Name: Eagle Crest Subdivision – Major Subdivision - Final

FILE # 20-94(3) TITLE HEADING: Final Plan/Plat - Eagle Crest

REVIEW COMMENTS FOR: Eagle Crest
TYPE OF REVIEW: Final Plans
REVIEWED BY: Jody Kliska

Re: Eagle Crest Final Plan/Plat - Our File #20-94(3)

FIGURE 33

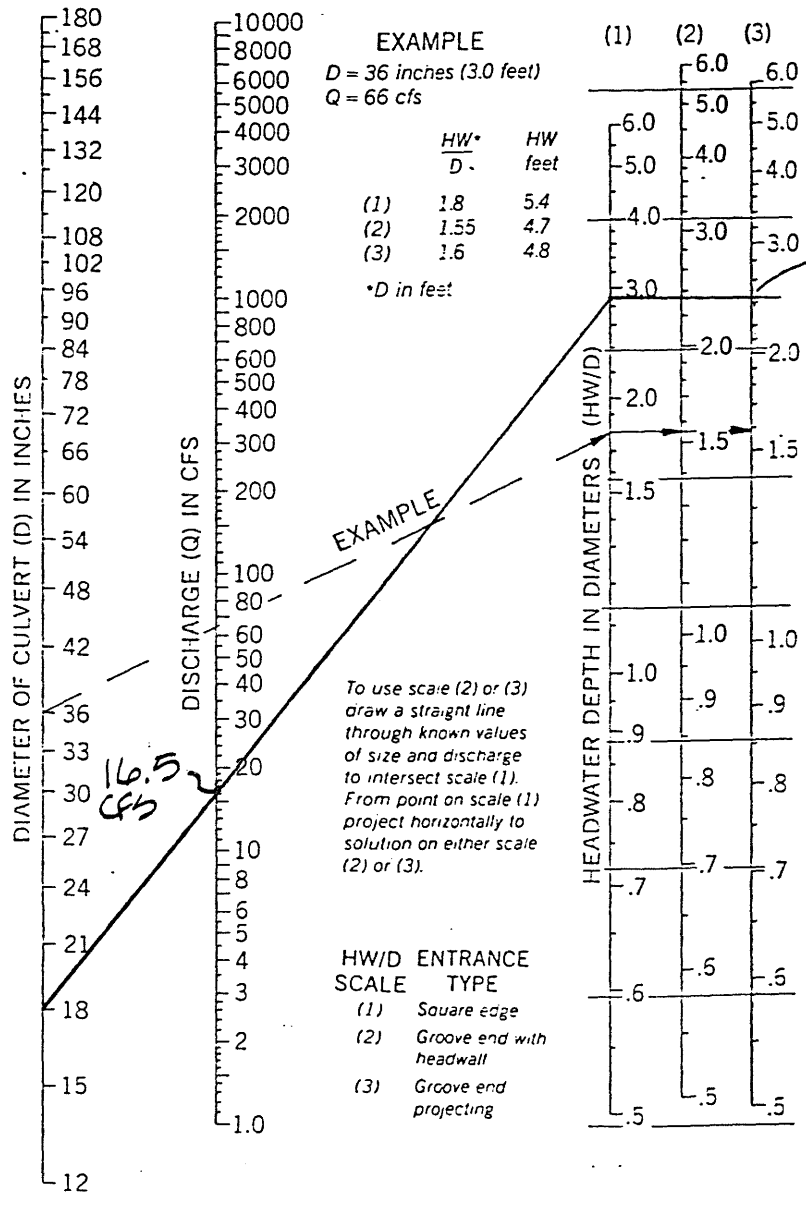
No analysis was included for the pipe at the intersection of Prospectors Point and the Eagle Crest Court. City minimum is a 12" pipe with minimum one foot cover, and it may be that the minimum is sufficient to carry flows. Please provide an analysis for this, as well as a profile showing minimum cover will be met. End sections for the pipe are required.

Based on field observations on October 20, 1994 by our office and the City Development Engineer, Jody Kliska, the proposed 18-inch R.C.P. culvert at the entrance has been eliminated from the design. The transitions from the proposed entrance road (Eagle Crest Ct.) to the existing roadway section of East Prospector Point will be made by backfilling with base material and graded to provide positive drainage towards East Prospector Point road and away from existing residential lots adjacent to Eagle Crest Ct. A note has been added to sheet ST-1 regarding positive drainage.
